## INSPECTION REPORT

Ref: MofGC 010425\_1

### MV Maid of Glencoul Bow & stern loading ramps

Vessel: Maid of Glencoul

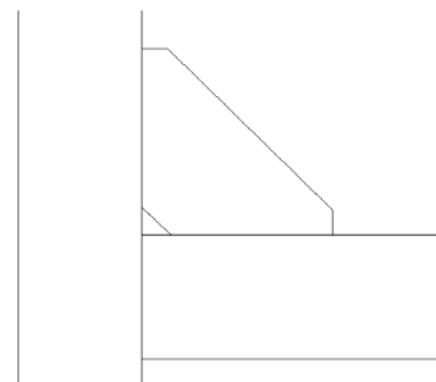
1. Failure and cracking of welds was noted on historic reinforcing and repairs to the flanges of the principle longitudinal structural members in way of the 2nd transverse some 900mm from the hinge line.

2. Numerous minor cracks where noted (as marked) at the connections of longitudinal and transverse flange and toes of bracket connections on the 1<sup>st</sup> & 2<sup>nd</sup> transverse grillage members

It is recommended that the top flanges are cropped over a length of approx. 700mm (as marked) and the material replaced with S235 20mm thk bar. All weld to be continuous and transitions to original lighter flange material to be tapered 1:4.

Care is to be taken to ensure a minimum of 75mm clearance between new flange butt welds and any existing web weld seams.

Many of these issues will be resolved as part of general flange repairs detailed in 1. above, but where this is not the case, the cracks are to be ground out, arrested and welds repaired.

Consideration should be given to fitting additional gusset plates outboard side of the connection between longitudinal & 2<sup>nd</sup> transverse member.
